ACCESS AUDIT REPORT

Shri Ram College of Commerce

Accessible University of Delhi

SAMARTHYAM

GENERAL PARKING

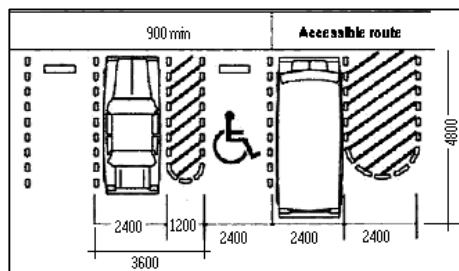
A designated parking lot was found for Student and Staff parking. No sign board was found to locate the parking lot.

- ✚ Parking area to be clearly specified with directional signage.
- ✚ Gate to have leveled flooring.

ENTRANCE TO THE MAIN BUILDING

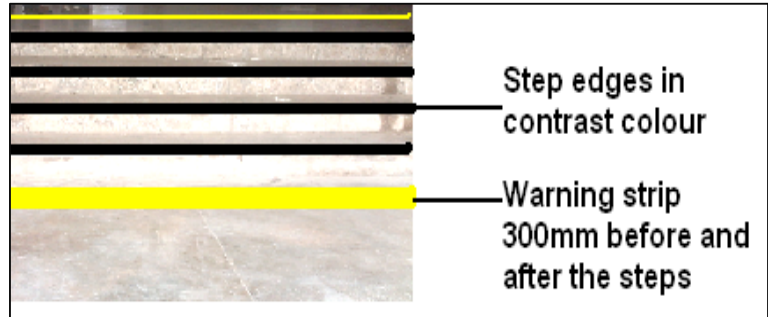
There are four steps (170 + 270 + 270+270mm) marking the front entrance to the college building.

- ✚ Steps to have edges in contrast colour (Annexure II) and warning strip (Annexure IV) 300mm before and after the steps.
- ✚ Directional information signage to be displayed for ramp at side and back entrance.

FEES DEPOSIT COUNTER

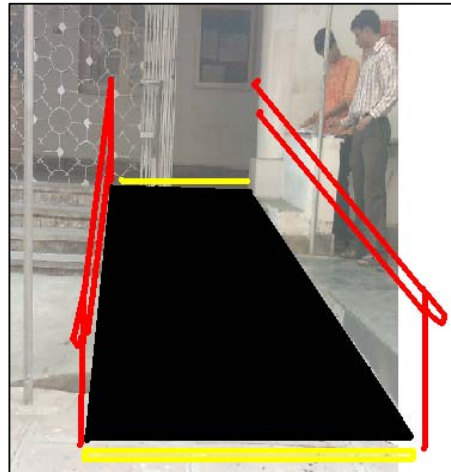
- ✚ Is fairly accessible

FOOT MAT

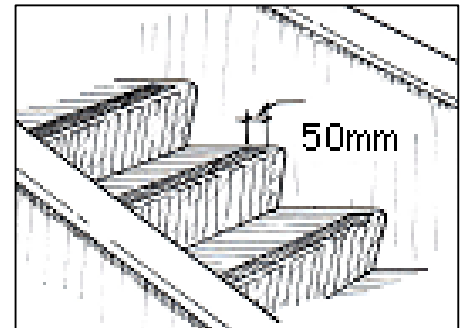
Good orienting cue for persons with vision impairment and low vision.

- ✚ To be placed for entrance to all departments, room and toilet entrances.
- ✚ However, coir foot mats to be replaced by bright colour (red/yellow/orange) rubber mats, as it is difficult to move mobility aids on thick coir mats.
- ✚ In all new constructions foot mats to be embedded in a niche (refer photo on right).

STEPS & STAIRS

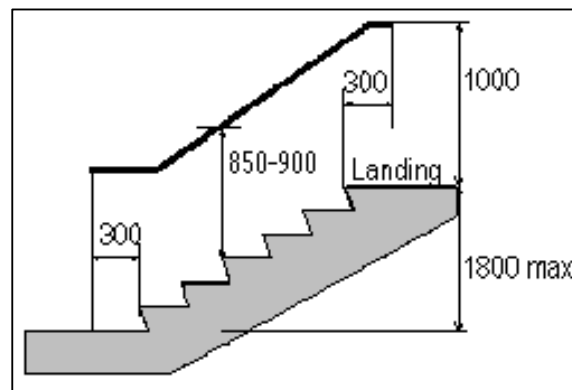
Many staircases connect the ground floor with other floors. There is no extension of handrails for first step and at many staircase handrails are missing.

- ✚ **Step riser** is 170mm, to be reduced to 150mm in all new constructions.
- ✚ Handrails to be provided on wall side also to help persons with reduced mobility to take support while descending.
- ✚ **Stair edges** (50mm min.) should have bright contrasting colors, which helps persons with low vision to identify height and depth of each step.
- ✚ Refer Annexure II for steps and Annexure III for handrail standards.

AUDITORIUM

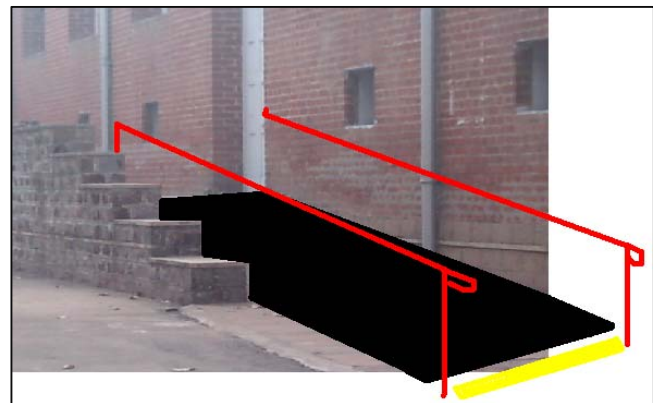
Ramp at the entrance is steep and with out handrails. Total height is 730mm and 8meter long ramp (gradient 1:12) should be provided.

STAGE

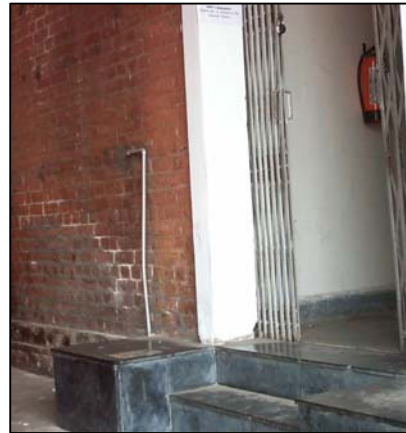
Front entrance to the Audi to have handrails (Annexure III) on the steps and step edges in contrast colour (Annexure II).

- ✚ 8 steps from the back entrance to stage, should have ramp as per Annexure I and III.

LIBRARY

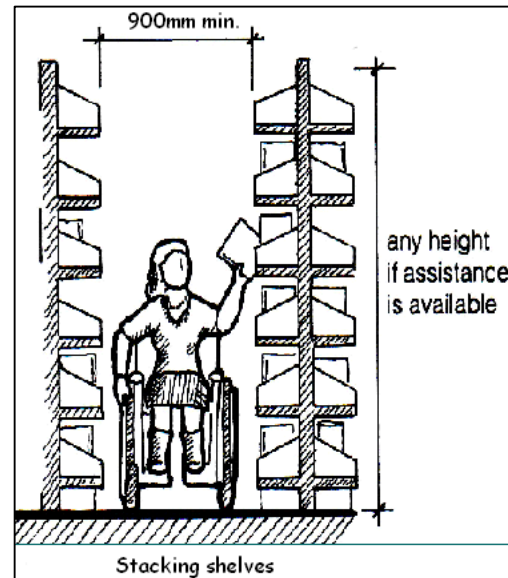
Book issue counter is at 1050mm

Aisle space between stacks is only 680mm.

- ✚ A lowered counter at 800mm height should be provided.
- ✚ Books in Braille and Screen Reading Software to be provided for persons with vision impairment.

- ✚ Aisle space (900mm min.) between stacking shelves/almirahs to be maintained for students using mobility aids.
- ✚ Stacking are lighting to be increased.

DRINKING WATER

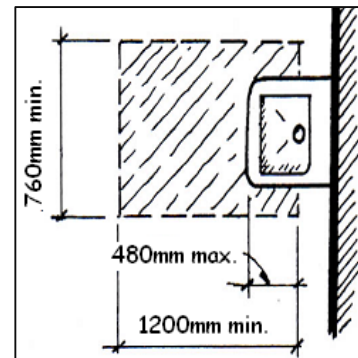
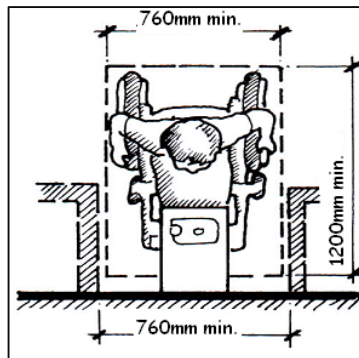
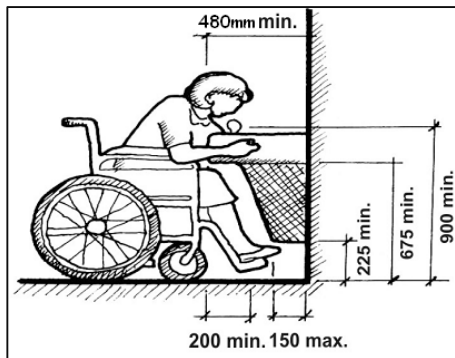
Drinking water near class room (height of the tap is 820mm) and one near library (tap height is 1300mm) has a step.

High taps and inadequate water drainage system makes it inconvenient to access drinking water for the general students also.

- Tap to be lowered down so that all operable parts are between 900mm-1000mm height.
- Leg and knee space to be provided (as shown in the diagrams) with basin to avoid spillage of water.
- This allows both front and parallel access to taps for students using mobility aids like wheel chair, crutches etc.
- Glazed ceramic tiles should be replaced by anti-skid/matt finish tiles benefitting everyone.
